REV.
J

AS1895™/1

RATIONALE

COUPLING, V-RETAINER, SINGLE LATCH,
TYPE I STANDARD PROFILE

FIGURE 1 - STANDARD PROFILE COUPLING

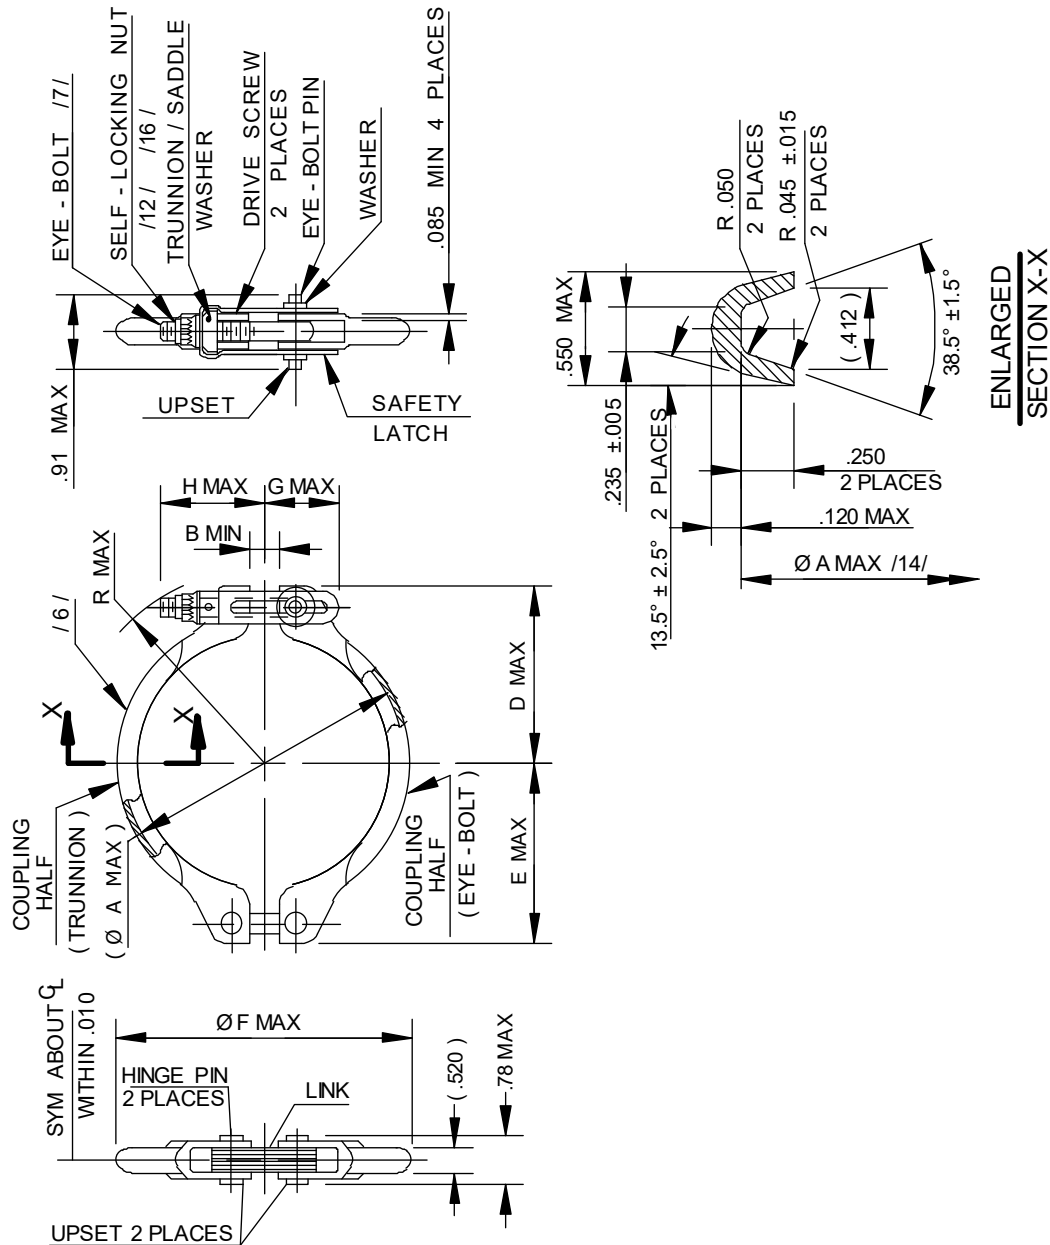
INTRODUCE OPTIONAL MARKING CODE FOR IMPROVED LEGIBILITY. REPLACE NOTE /16/ WHICH CURRENTLY SPECIFIES TO USE DRY FILM LUBRICANT ON NUTS WHERE THEIR ENVIRONMENT WOULD BE ABOVE 1000 °F BY THE NOTE TO ADD CODE LETTER "L" WHEN NUTS REQUIRE DFL. REASON: CURRENTLY, BOTH SILVER PLATED AND DFL NUTS ALREADY MEET THE 1200 °F TEMPERATURE REQUIREMENT OF THE PROCUREMENT SPECIFICATION, AS1895.
